Our Reference: J6558

**Development Application 10.2022.134.1 – Response to Submissions
1 Dingo Lane, Myocum**

BYRON SHIRE COUNCIL
DINGO LANE SOLAR FARM
BYRON BAY, NSW

CAD FILE: T:\J6558 - DINGO LANE SOLAR FARM BSC\7 - DRAFTING\0320 TYPICAL SECTIONS SHEET 1.DWG PLOTTED BY: NVO PLOT DATE: 21/10/2022 1:02:06 PM

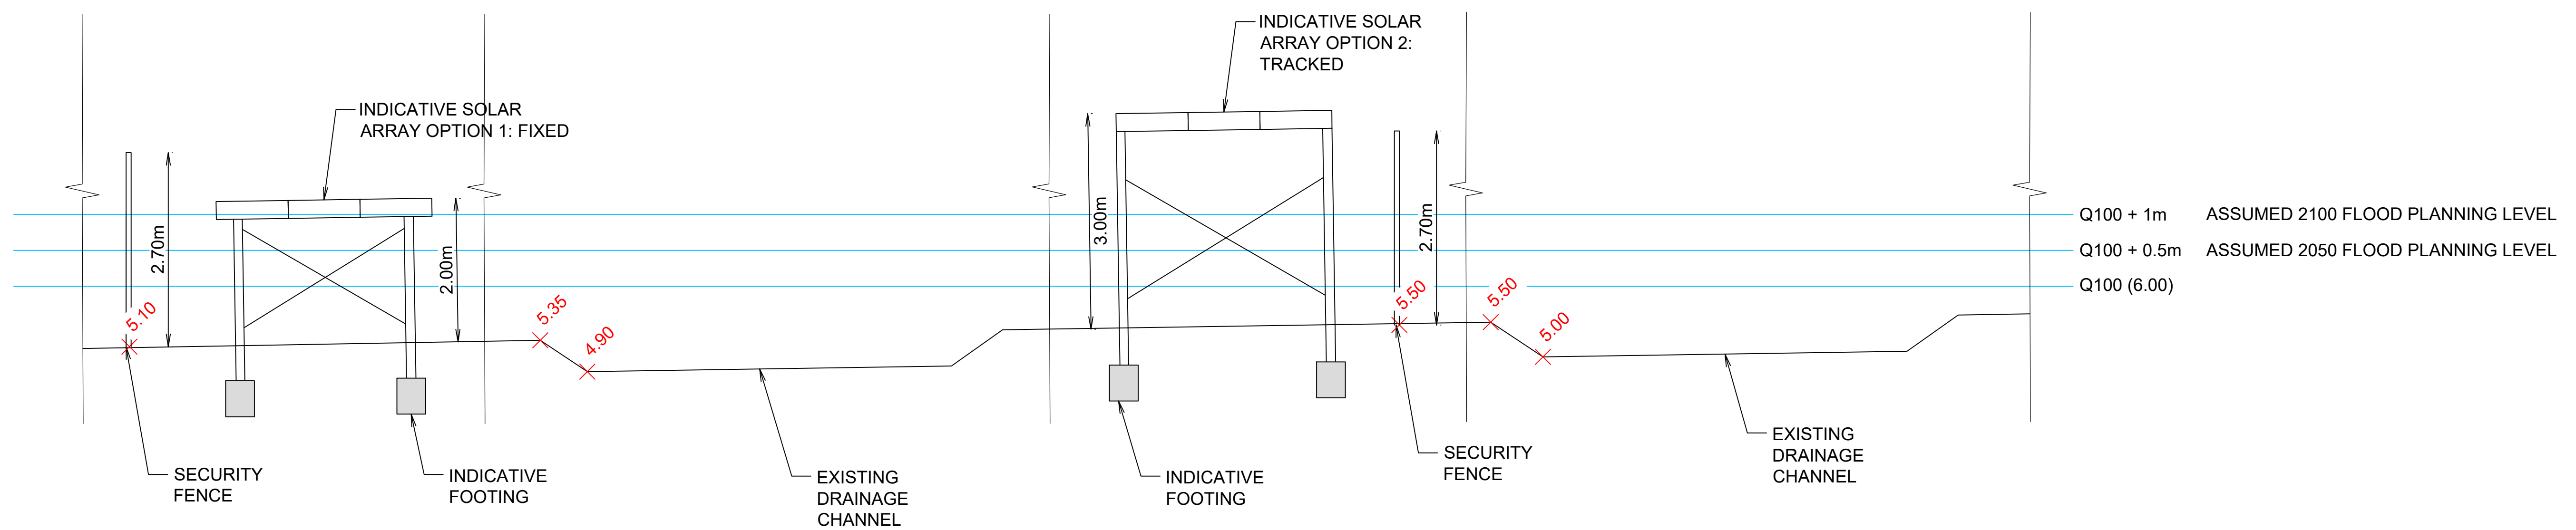
- Plan details of the viewing platform and solar inverter building, including details of earthworks required to construct these buildings/structures.
- Written dimensions on the plans of the height of the solar arrays, including an indication of their height in relation to flood levels.
- Confirmation regarding 'integrated development' status with the *Water Management Act 2000*.

- Enclose an additional plan within the planset providing additional detail of the solar inverter building, including associated earthworks. As displayed, earthworks are effectively confined to the 'boxing out' of access roads and 300mm raising of the solar inverter building pad. Whilst the solar inverter is already positioned above the Q100 flood level + 0.5m freeboard, the raising of the inverter pad results in alignment with climate change scenario projections, being Q100 flood level + 1m. We understand this additional information resolves this matter.

- Enclose an additional plan within the planset displaying the height of both the fixed and tracking solar array systems in relation to:
 - the Q100 flood level, as currently adopted,

- Q100 + 0.5m, effectively equating to a 2050 Q100 climate change projection, and
 - Q100 + 1m, equating to a 2100 Q100 climate change projection.We understand this additional information clarifies and resolves this matter.
